ITEM 1: Nation’s Giant Hamburgers Remodel and Variance, AP-21-1603 (AD, VA)

Memorandum

RE: **Consideration of Administrative Design Review and a Variance from the Required Yard Setbacks for Nation's Giant Hamburgers Remodel, AP-21-1603 (ADR, VA)**

Approving Administrative Design Review)	Resolution No. 382
to Remodel the Existing Façade, Apply)	
New Paint Colors, Construct a 563 Square)	
Foot Addition, Construct a New Trash)	
Enclosure, Restripe the Parking Lot, and)	
Add Landscaping, Along with a Variance)	
to Reduce the Rear Yard Setback from 10)	
Feet to Zero Feet for "Nation's Giant)	
Hamburgers Remodel," at 3789 Railroad)	
Avenue.)	
Assessor's Parcel Number 088-071-024.)	
_____)

SITE PLAN

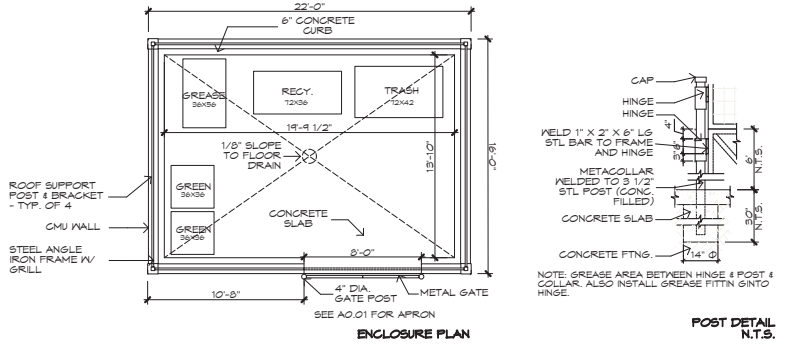
15. Sidewalk. Replace hazardous sidewalks and non-ADA complaint driveways, refer to city of Pittsburg Standards (R4) or Contra Costa County Standards (CA72) for driveway approach.

16. Accessibility. The applicant shall submit ADA signage details and provide grades for driveways and accessible paths.
17. Drainage. The applicant shall submit drainage plan and show existing area drains. The applicant shall, wherever possible, drain impervious surfaces to landscaping; and use curb cuts for parking area to drain to landscaped sections.

1 SITE ELECTRICAL PLAN
E31 SCALE: 1" = 10' - 0"

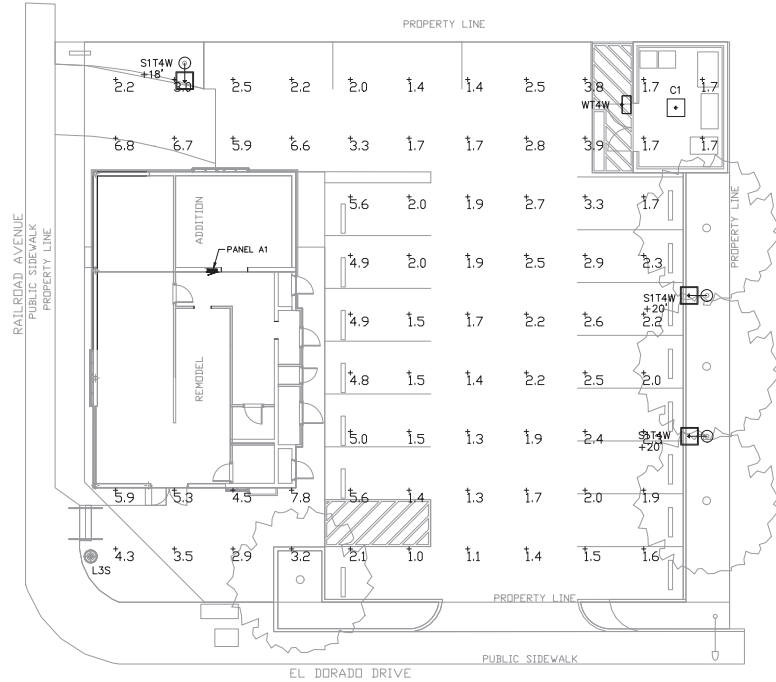
18. Light Pole. The applicant shall either relocate the northwestern-most proposed light pole farther north; or replace the proposed light pole with a light pole with a shorter overhang, in order to provide clearance for waste collection vehicles which require a 14' vertical clearance and 10' horizontal clearance.
